November 21, 2016
BOARD OF COUNTY COMMISSIONERS
ORANGE COUNTY, FLORIDA
Addendum No. 2, IFB Y17-713-CC
BARNETT PARK AIR HANDLING UNITS REPLACEMENT

1. Revision: The following attached drawings have been revised:

Project:
Barnett Park AHU Replacement

M202

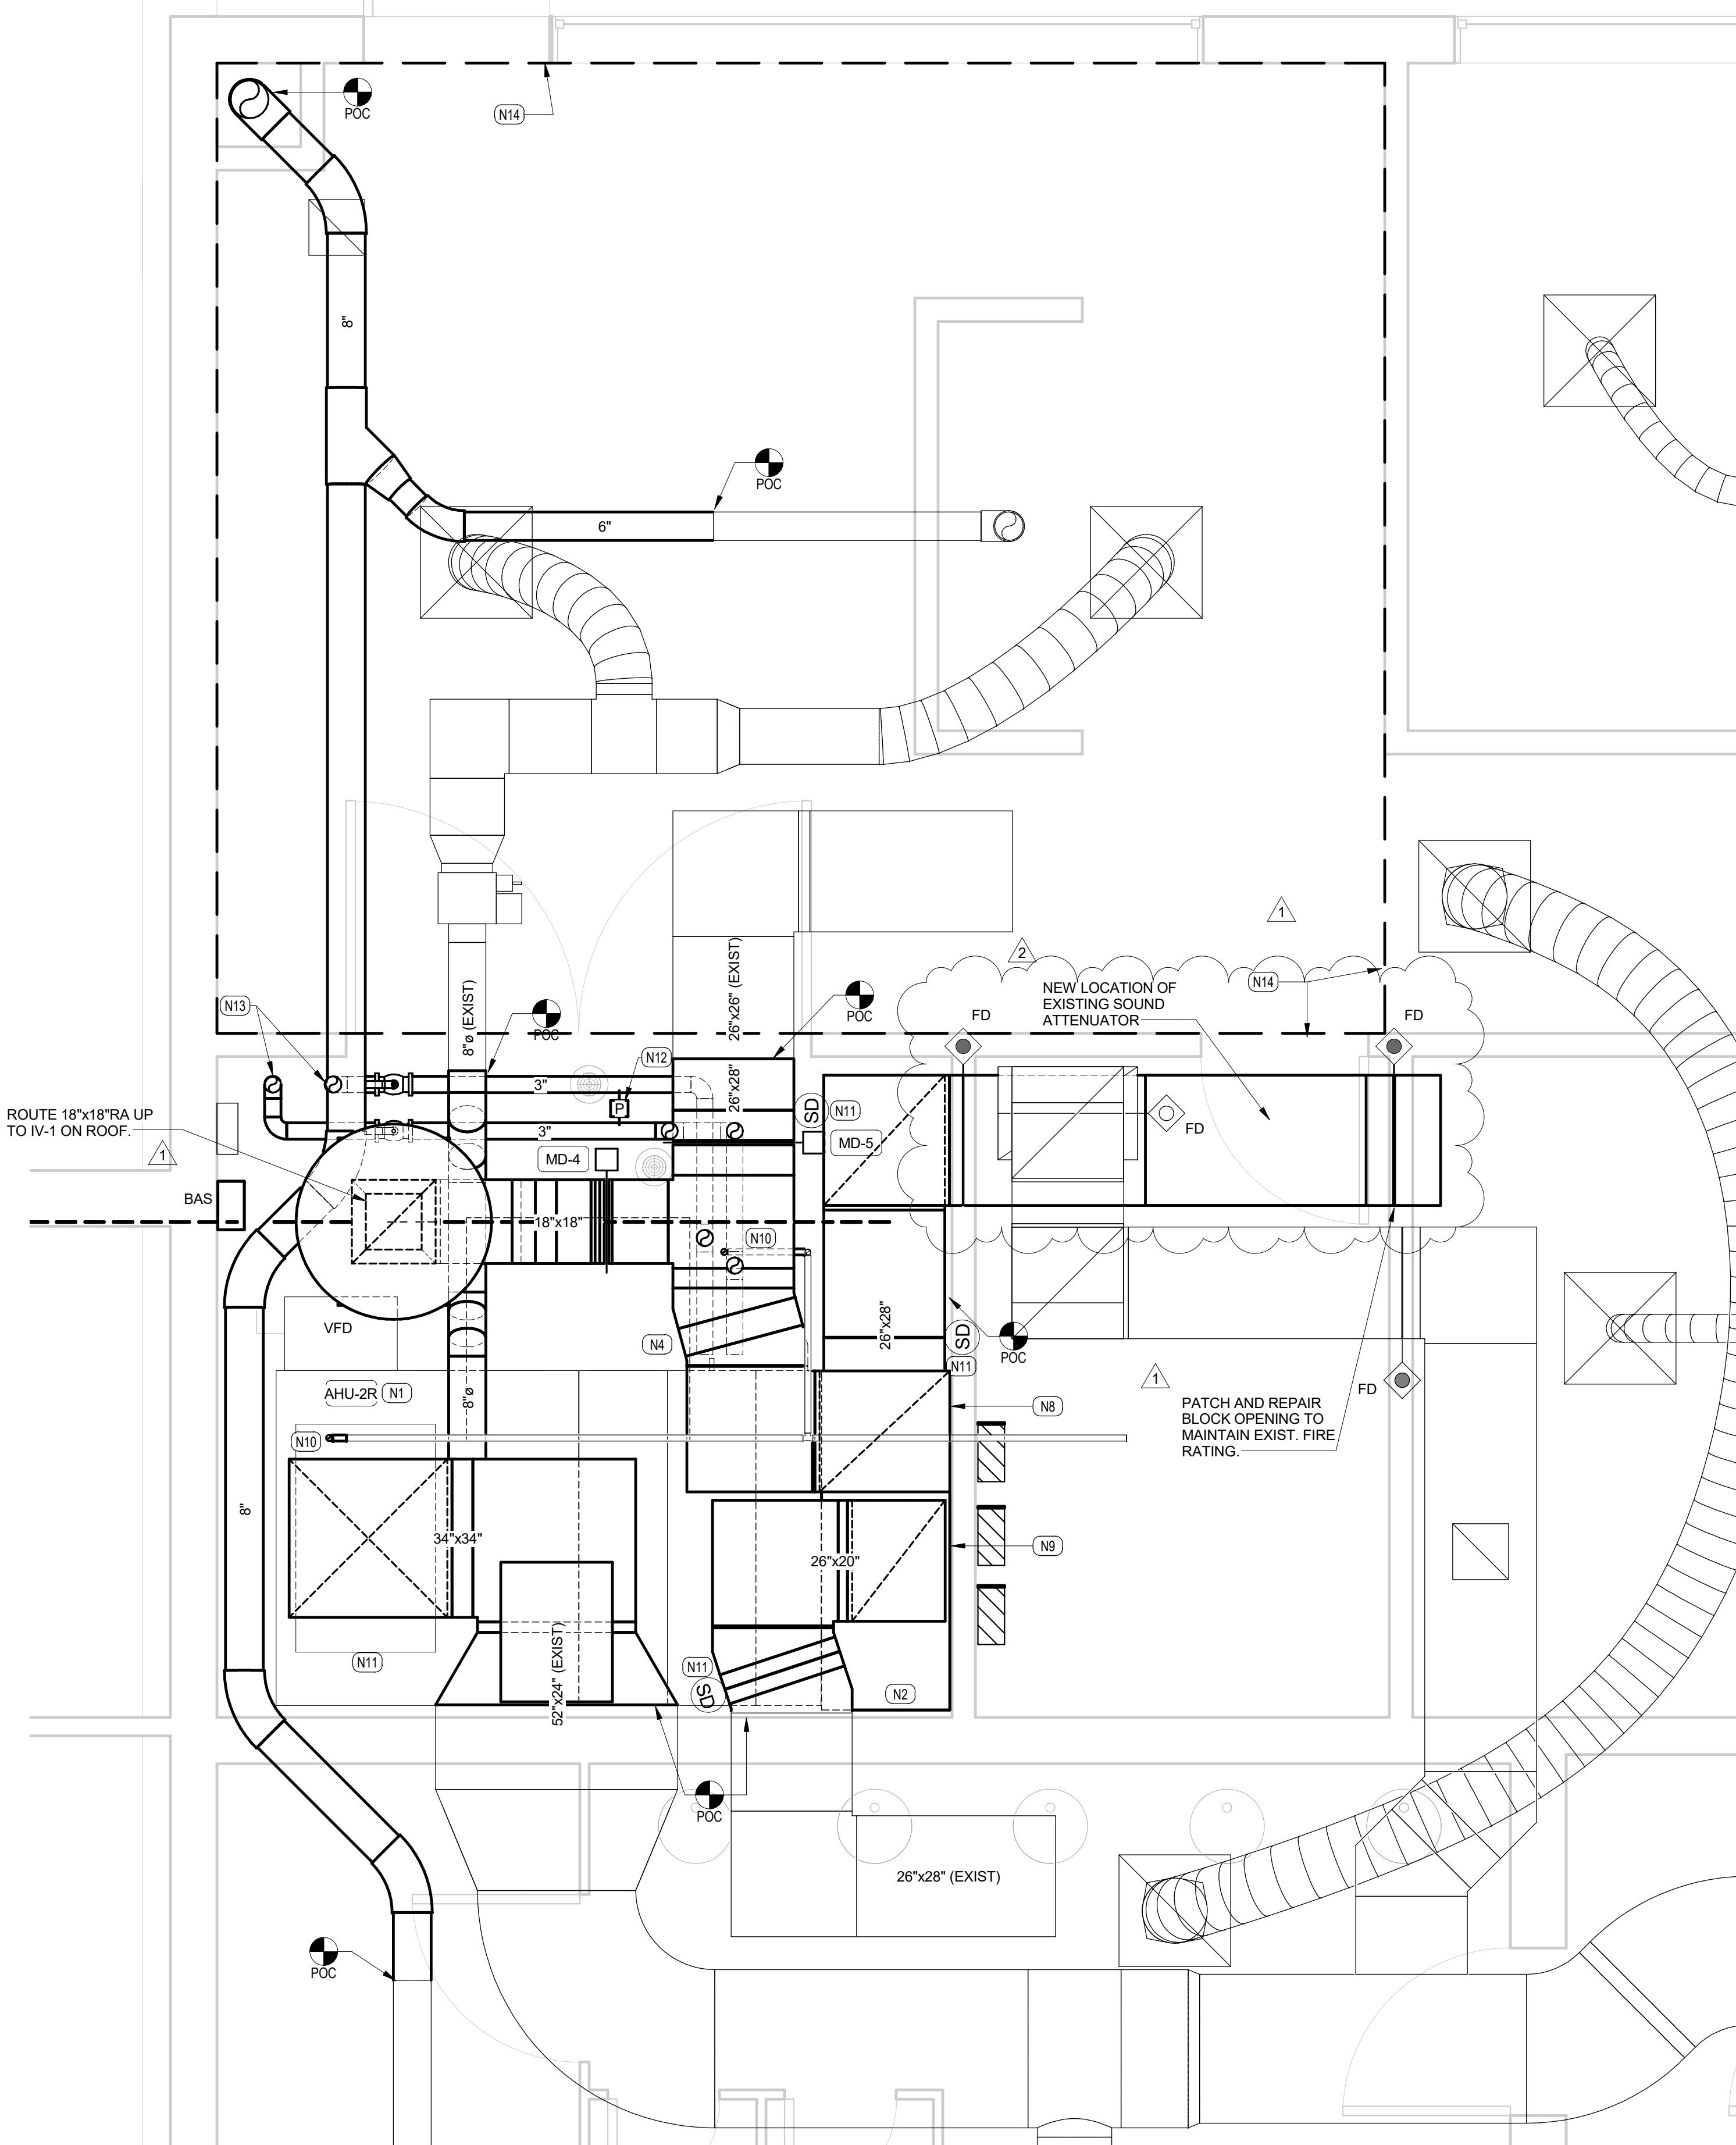
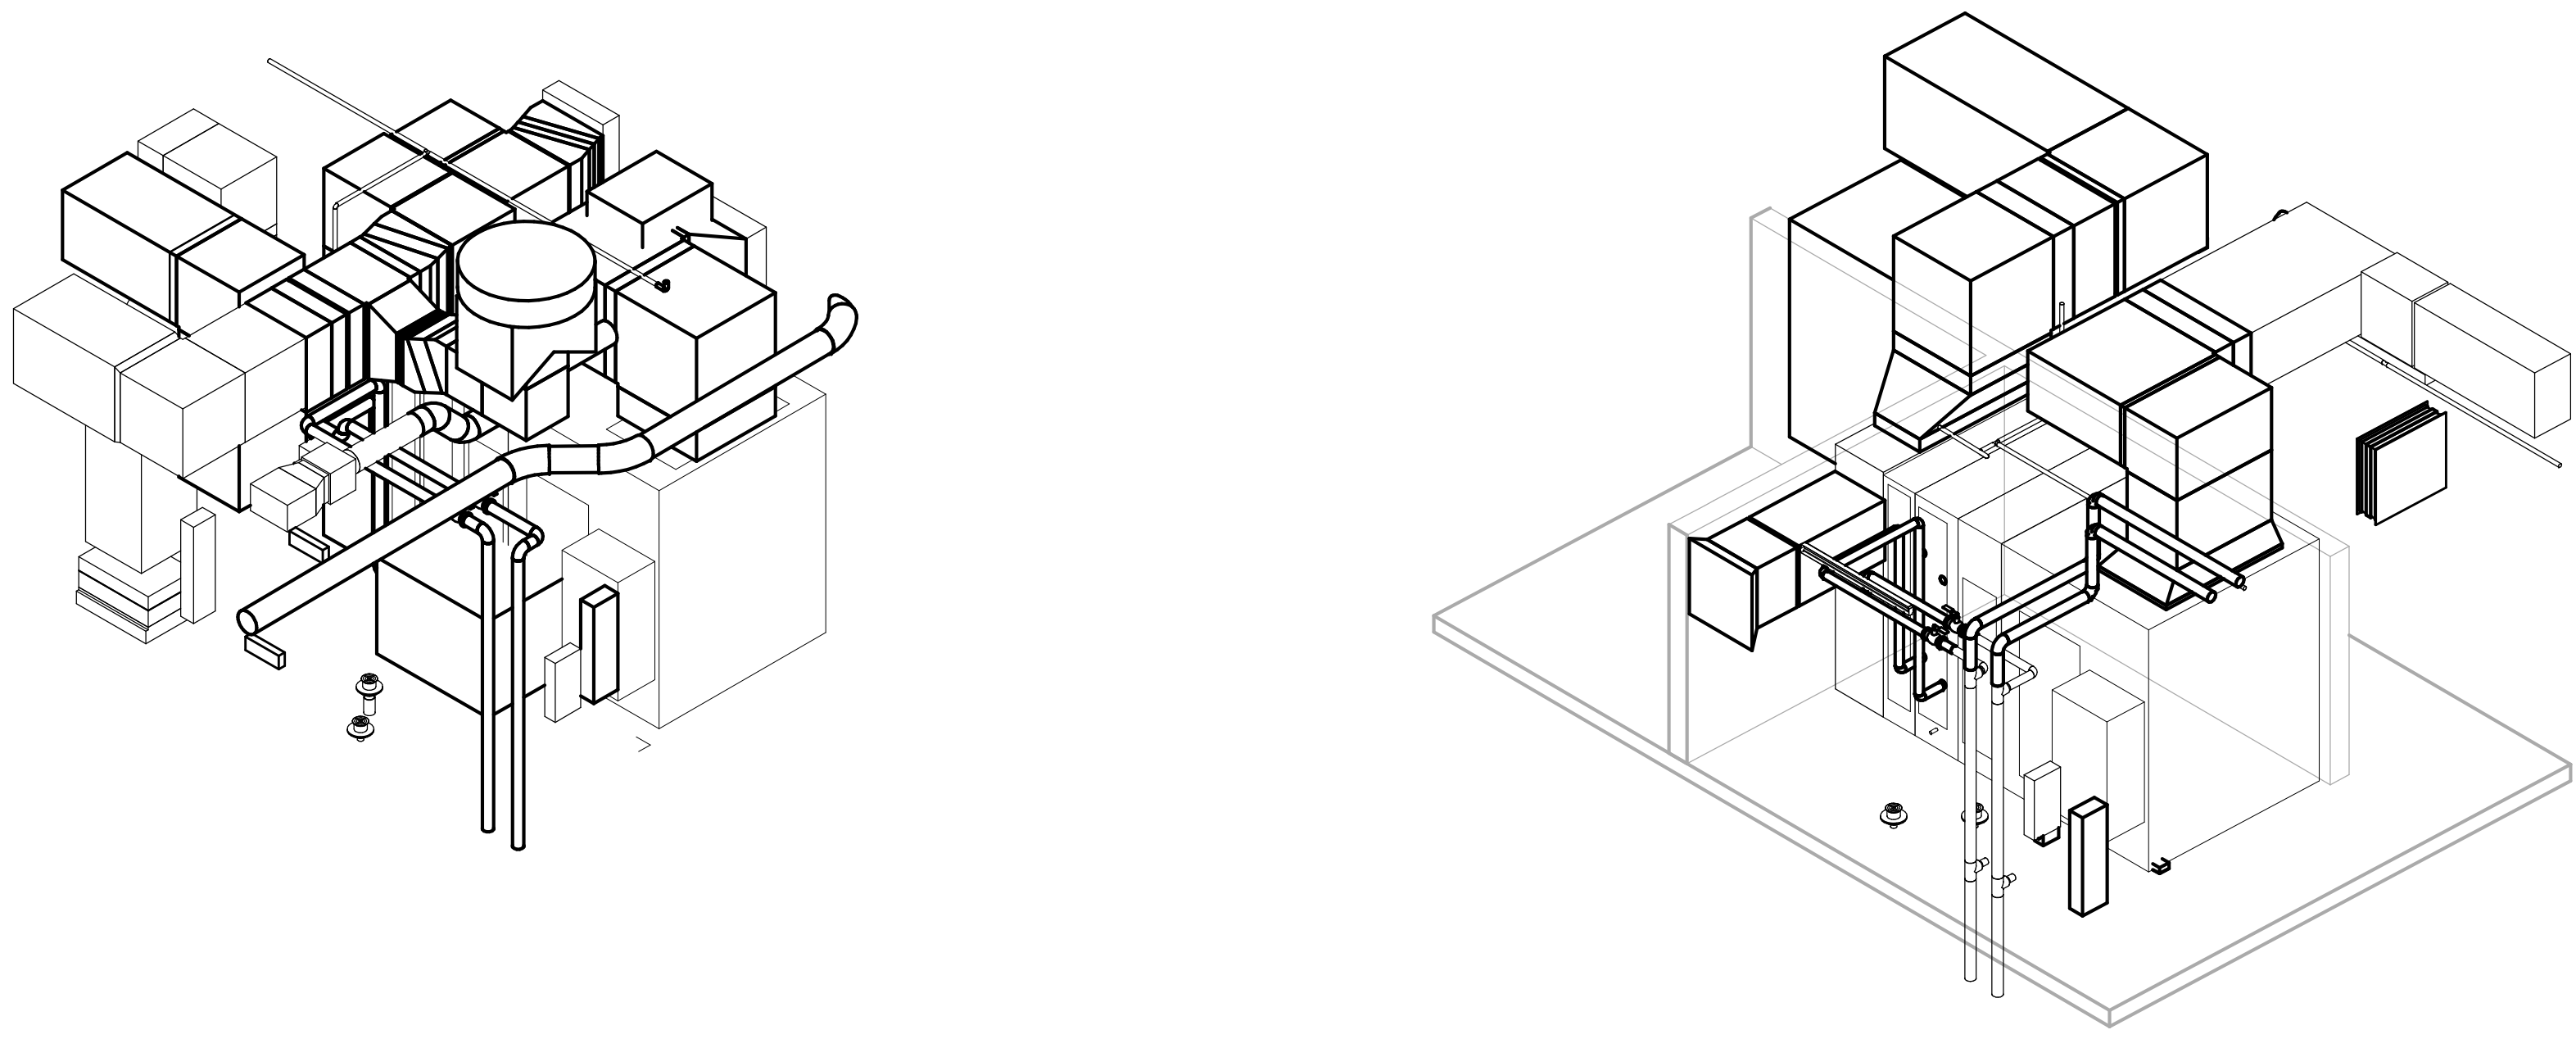
a. M202 dated 11/15/16 - Added fire dampers. Revised sound attenuator location.

6. **Question:** Drawing M202, on the second floor mechanical phasing plan, shows the sound attenuator being relocated in a fire wall. Is a fire damper not required? Please clarify.

11. Question: Drawing M202, New Plan Note N7 states to install a 36x36 transfer opening above a fire rated ceiling. What type of wall is the transfer going through CMU or drywall? And is it a fire rated wall? Please clarify.

Answer: Fire dampers will be required in wall. Sheet M202 has been revised to reflect this change.
7. **Question:** Drawing M103 states to reroute a vent pipe to accommodate the new duct. Please clarify the size and material of the vent pipe. Also, will rerouting require a new roof penetration?

Answer: The wall the transfer will be constructed in is CMU and the transfer opening will be constructed about the fire rated lid and does not require any fire dampers.
